**RE: Echo Bay Mines Ltd., Lupin Gold Mine, Contwoyto Lake, NT.; Water Licence
NWB1LUP0008; 2002 Annual Geotechnical Inspection**

2002 GEOTECHNICAL INSPECTION OF PERIMETER TAILINGS DAMS

LUPIN MINE NUNAVUT

Re: 2002 Report on Annual Geotechnical Inspection
Perimeter Tailings Dams, Lupin Mine, Nunavut

PROJECT		Annual Inspection of Perimeter Tailings Dams	
TITLE		Dam 1A Inspection Photos	
PROJECT No.	0256-004-02	DWG. No.	Figure 5
		REV.	0

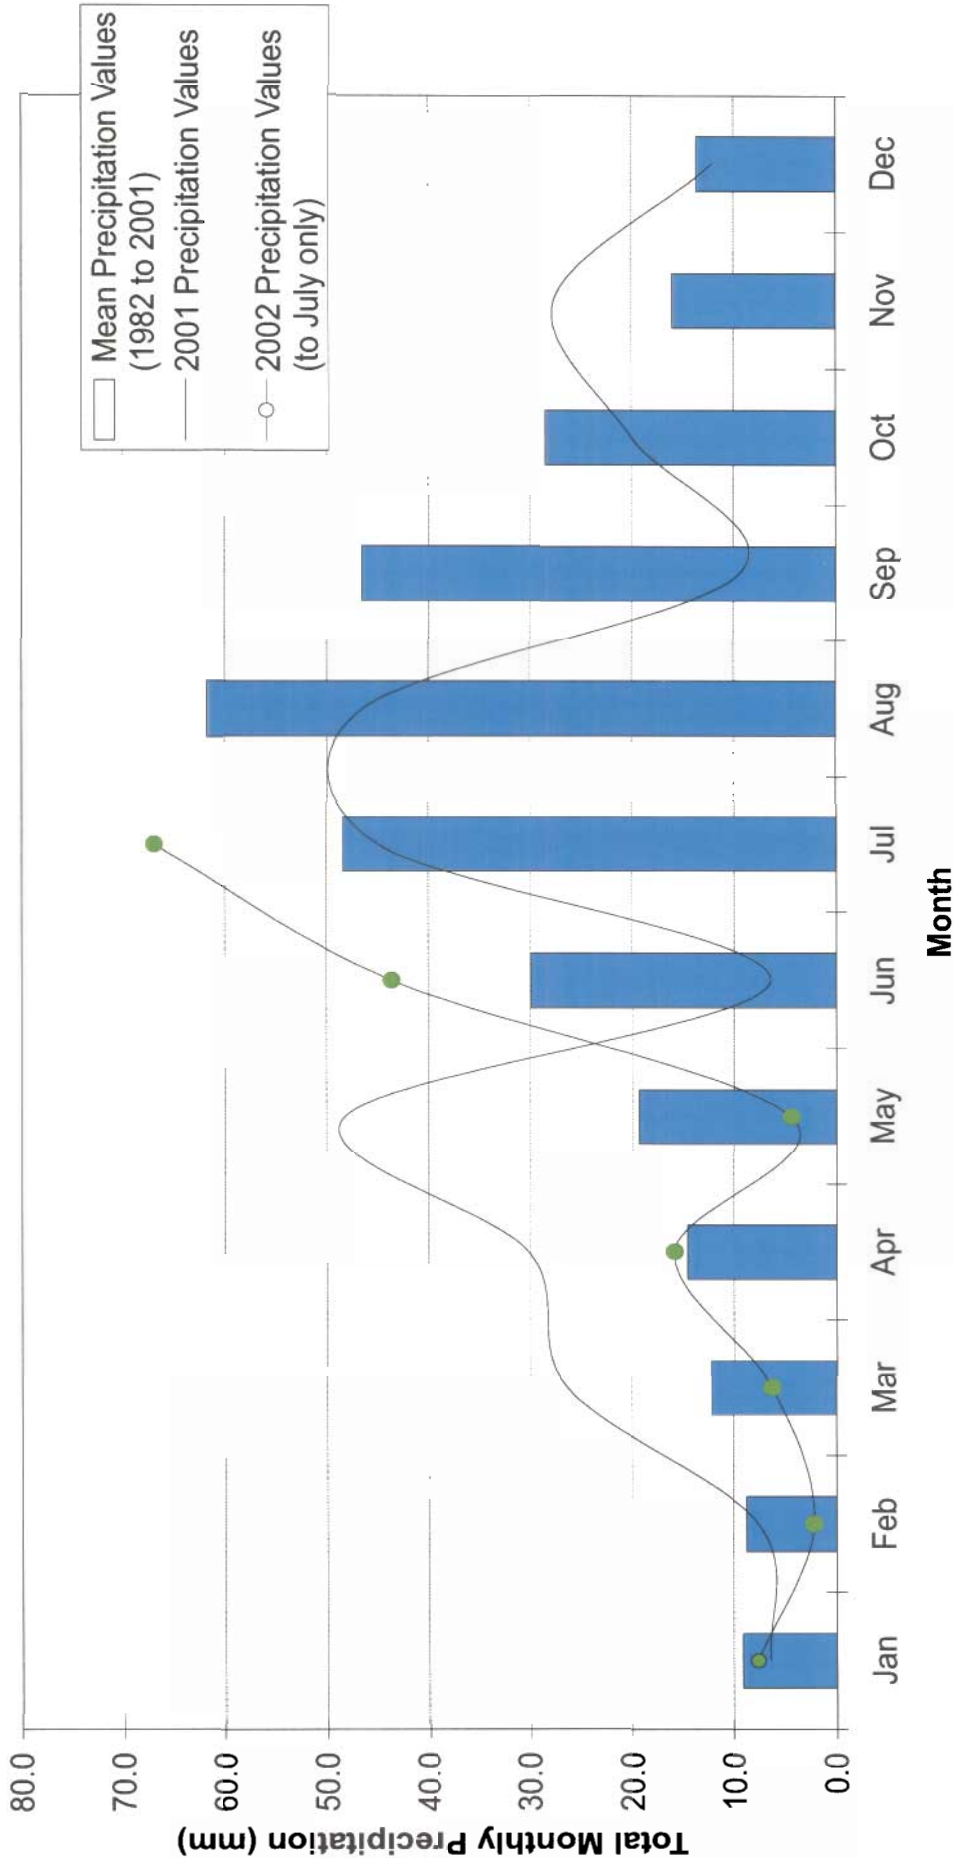
Photo 66 shows a small sinkhole just immediately to the right of the thermistor installed previously. This sinkhole had been noted previously.

Photo 70 shows the little scarps formed by the retrogression of the material right at the toe of the access road berm.

RECOMMENDATIONS: Minor crest sinkhole to be backfilled. Downstream toe berm sideslope needs to be flattened to prevent recurrence of cracking.

PROJECT	Annual Inspection of Perimeter Tailings Dams
TITLE	
Dam 2 Inspection Photos	
PROJECT No.	0256-004-02
DWG. No.	Figure 8
REV.	0

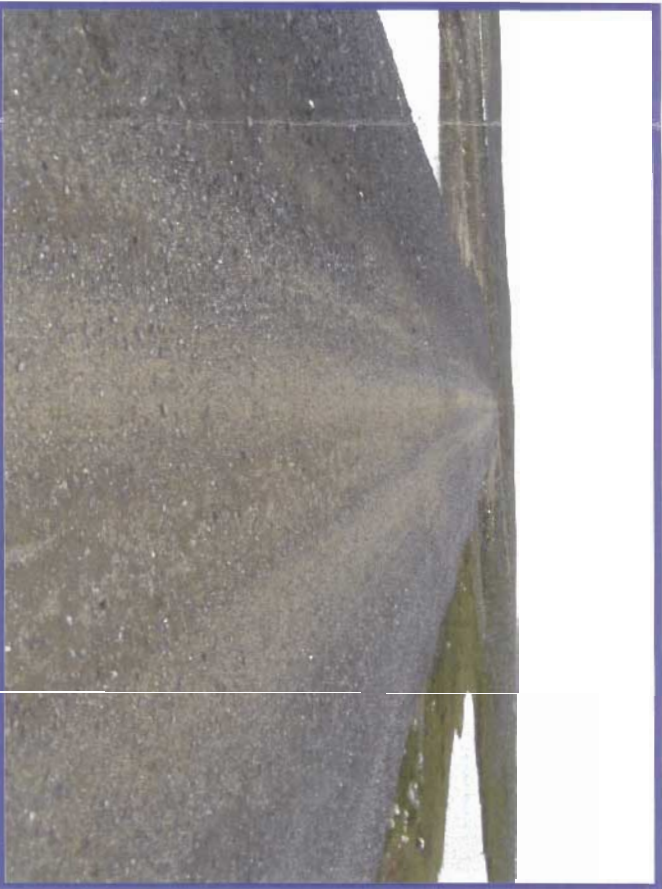
Photo 59 shows one significant erosional gully located on the downstream face at the north abutment.

Photo 51 shows some minor cracking along the downstream toe. This cracking has been previously noted.

- Minor erosional gulley on the downstream slope near the north abutment should be backfilled.
- Very small amount (<1 l/min) of seepage observed again at the toe of the north abutment. Continue to monitor seepage for any increases in quantity and to observe if seepage water contains any sediment.

PROJECT	Annual Inspection of Perimeter Tailings Dams
TITLE	Dam 3 Inspection Photos
PROJECT No.	0256-004-02
DWG. No.	Figure 9A
REV.	0

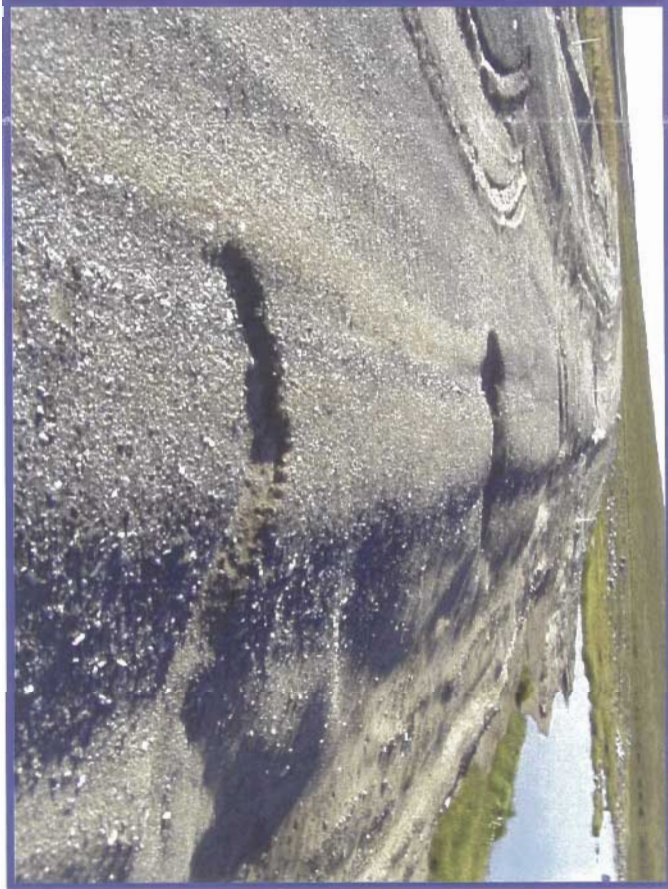
Photo 137 Shows some boulders and cobbles that appear to have been placed in a low swale area. At the current time, the swale work is very disturbed and would likely be ineffective in transmitting any water. The material should be excavated and a proper swale should be laid out.

Photo 139 Shows the toe of this dam. There are 6 erosional gullies existing at the edge and progressing to the crest. Each of these gullies should be backfilled.

Photo 142 Shows a number of tension cracks within this toe area. The cracks are discontinuous but can generally be observed over a distance of some 10 to 15 m.

- An informal "swale", consisting of sand, gravel and cobbles, appears to have been constructed near the southeast corner to convey surface cell water to Boomerang Lake. The swale is poorly constructed and appears ineffective in conveying water to the toe of the dam. The swale should be reconstructed to properly convey water across the dam.

- Several remnant and possibly new erosional gullies were observed at the toe of the east arm. All of these gullies should be backfilled to prevent any further erosion from occurring.

- Several longitudinal and oblique tension cracks were noted along the toe of the eastern arm of the dam. The cracks should be graded over to prevent the infiltration of any surface water.

PROJECT		Annual Inspection of Perimeter Tailings Dams	
TITLE		Dam 4 Inspection Photos	
PROJECT No.	DWG. No.	REV	
0256-004-02	Figure 10	0

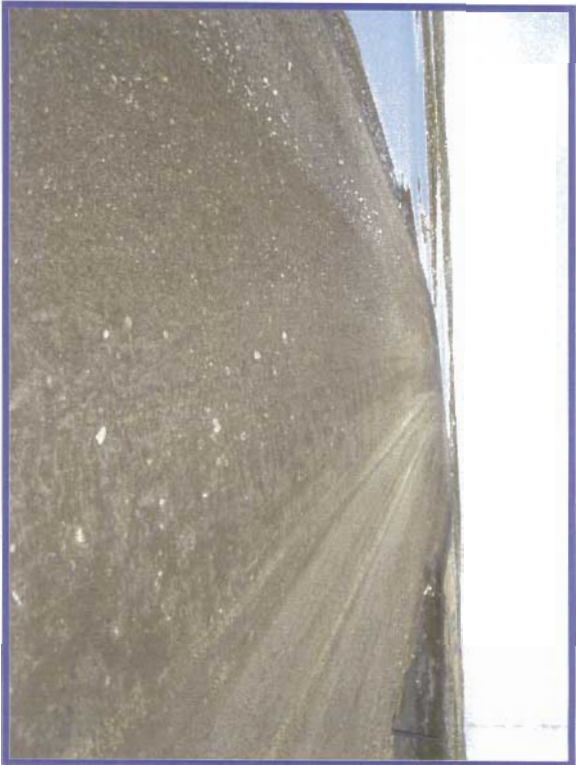
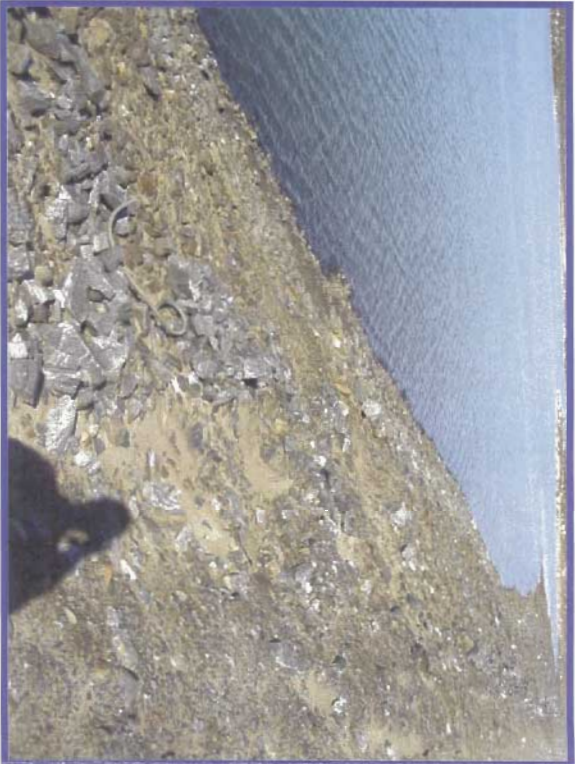
Photo 115 shows some of the disturbed area on the upstream side riprap. It appears that additional material has been placed on the crest and was graded over, perhaps to correct some of the earlier rutting caused by construction activity. The large number of boulders that have segregated out on the side of the fill to confirm appears that assumption.

Photo 119 shows another view of the disturbed area on the upstream side, likely as a result of original construction activity.

Photo 130 Shows the small pond which is located between the toe of Dam 4 and the small berm on the left of the photo. This area is pumped dry for the following two reasons; 1.) allow inspection of the downstream toe and 2.) to confirm the origin of the water in the pond.

- Dozer /construction activity on the upstream side has disturbed the rip rap placement, exposing the underlying sand at some locations. Consideration should be given to regrading the materials to an overall consistent slope to prevent the concentration of surface runoff.
- No other maintenance is suggested.

PROJECT		Annual Inspection of Perimeter Tailings Dams	
TITLE		Dam 6 Inspection Photos	
PROJECT No.	0256-004-02	DWG No.	Figure 12
		REV.	0

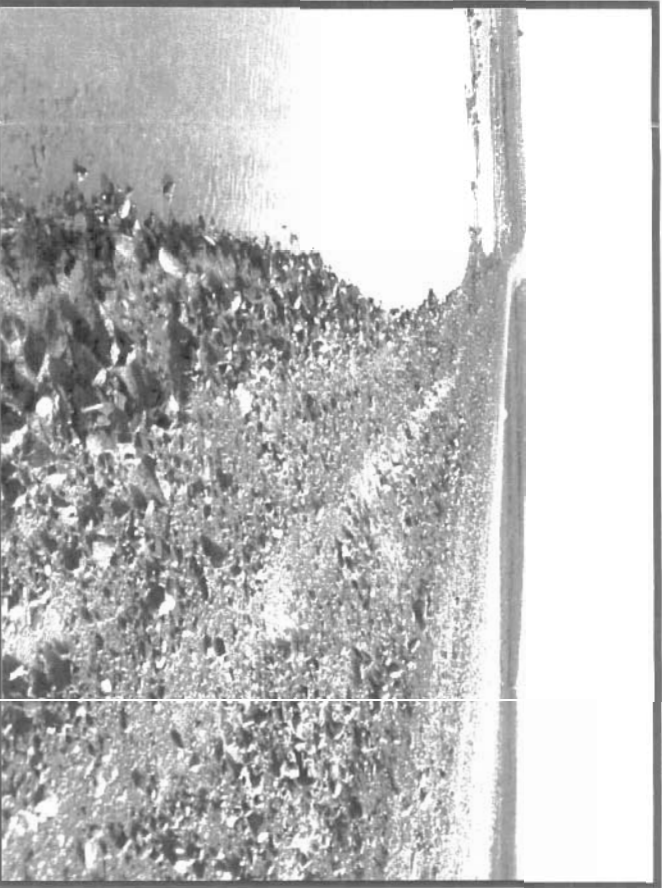
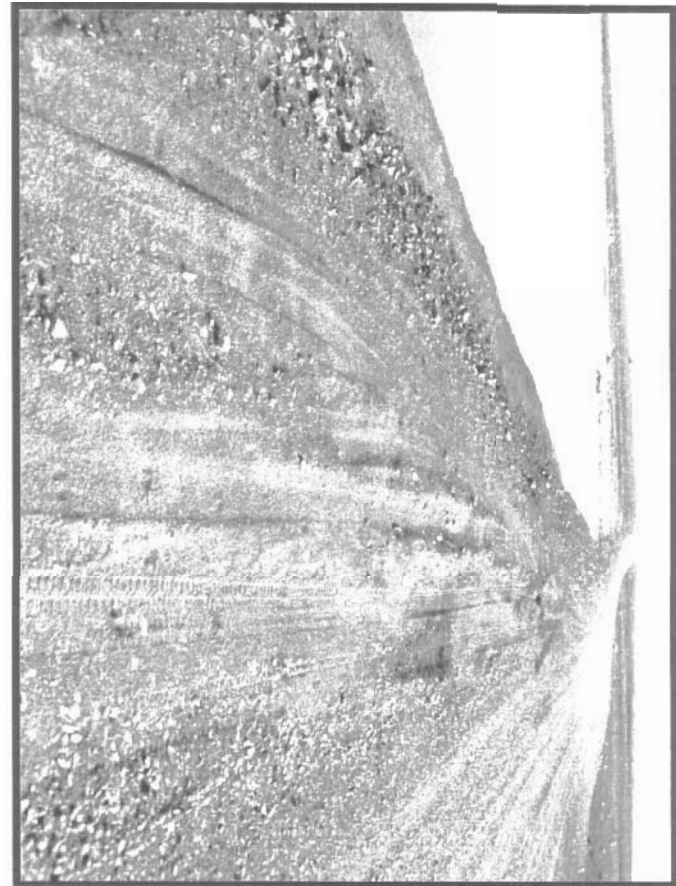
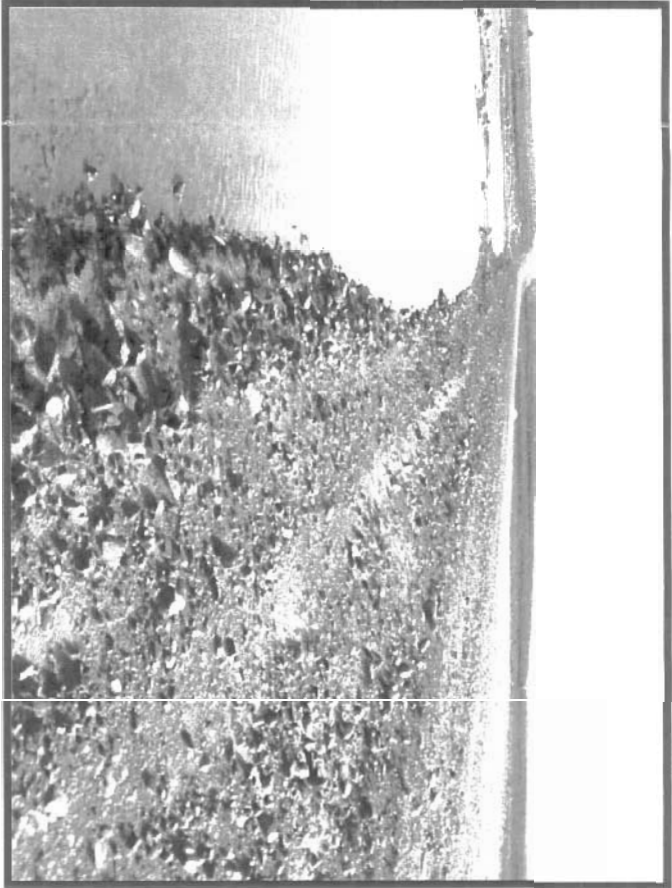
Photo 92 shows some rutting caused by vehicle traffic on the upstream side of the crest, towards its north abutment.

Photo 99 shows one minor sinkhole located near the downstream side of the crest. This sinkhole is located some 50 m north of the south abutment.

Photo 102 shows a significant erosional gully located on the downstream toe. This gully is located some 40 m south of the north abutment.

- One minor sinkhole in the crest and one erosional gully at the toe (~40 m south of north abutment) should be backfilled and graded.
- No other maintenance is suggested.

Long Term Plot for Deep Nodes in D1A-00-01
(Crest of Dam 1A, South End)

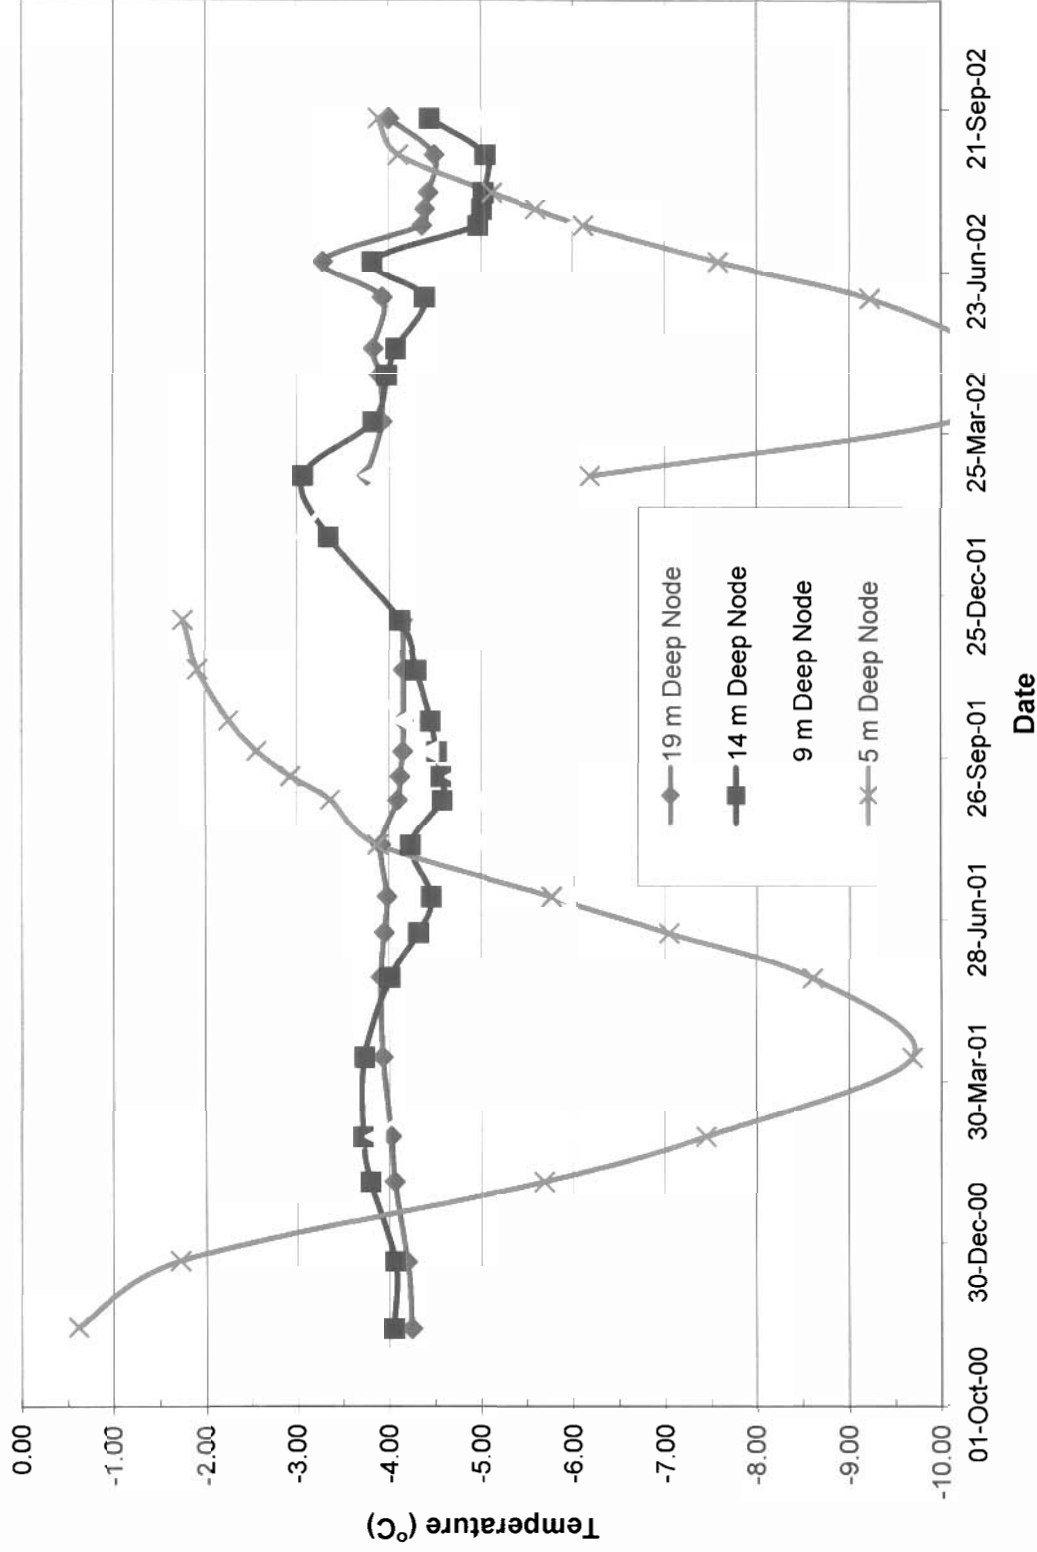
Thermistor D1A-00-1, just south of the mid-point of the dam, displayed an active layer of just less than 3 m in October 2001 and approximately 2 m depth by mid-September 2002. All nodes below active layer depth are subzero. Nodes below depth of 9 m (situated approximately below the embankment fill) are colder than -3°C with no signs of significant warming.

Long Term Plot for Deep Nodes at D1A-00-02
(Crest of Dam 1A, North End)

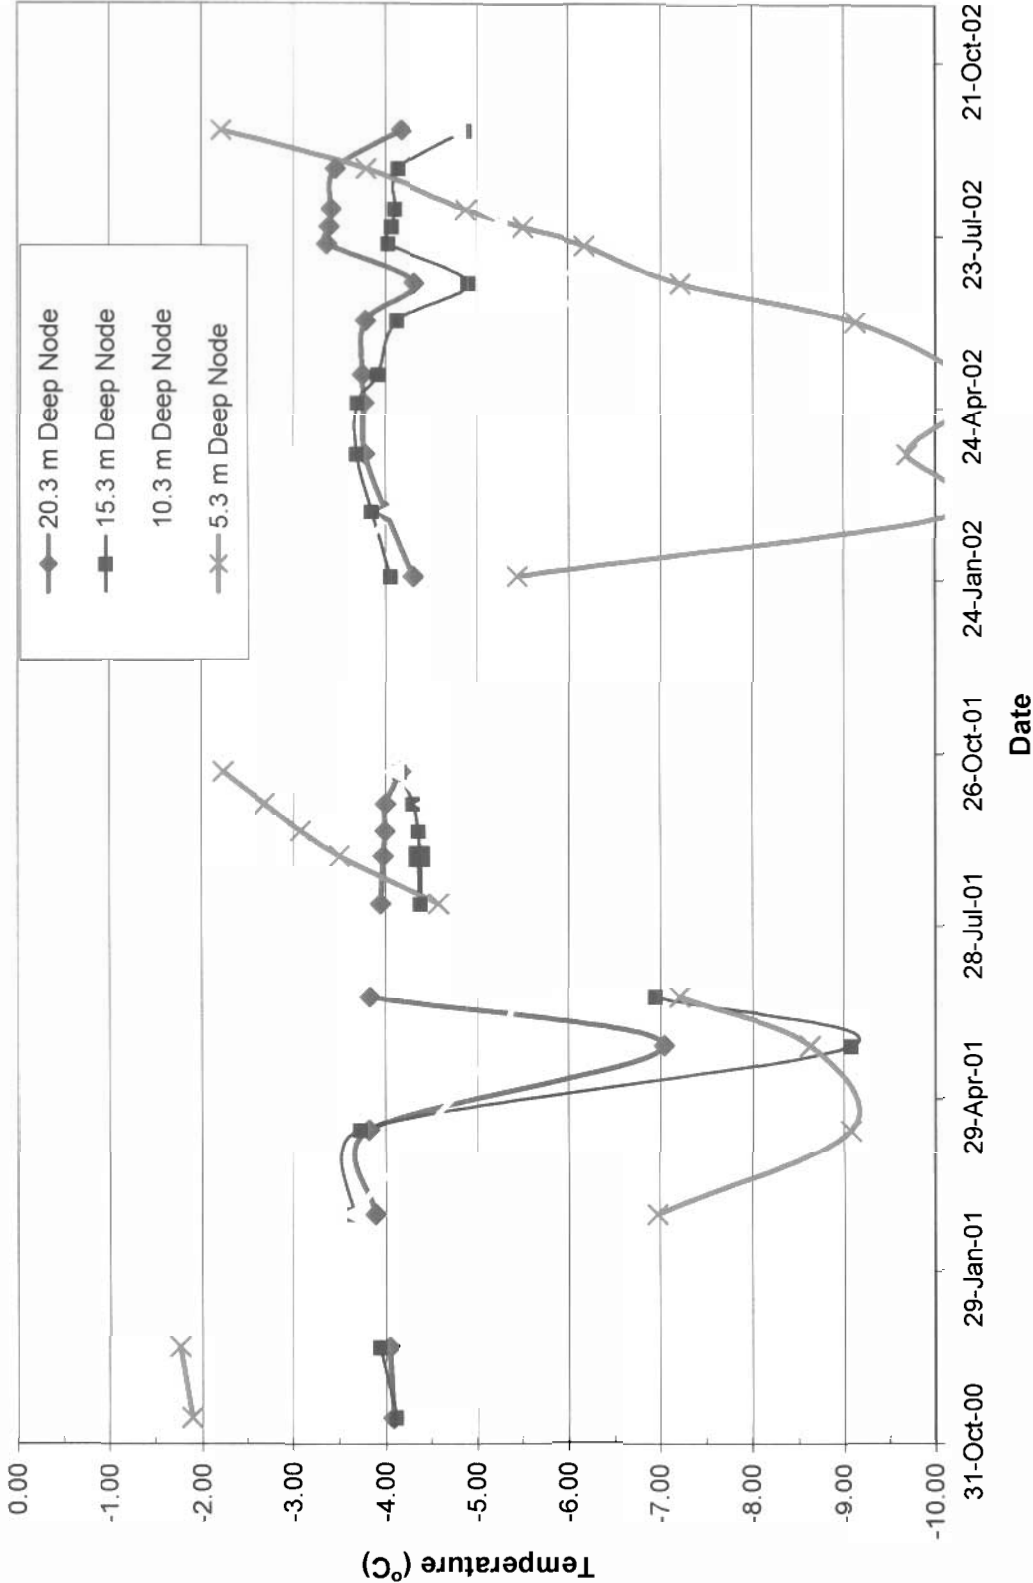
Thermistor D1A-00-02 is located towards the north end of the dam. Active layers depths in excess of 3.3 m were recorded in October 2001 and mid-September 2002. No indications of warming at depth. Nodes below depth of 10 m appear to be colder than -3.5°C .
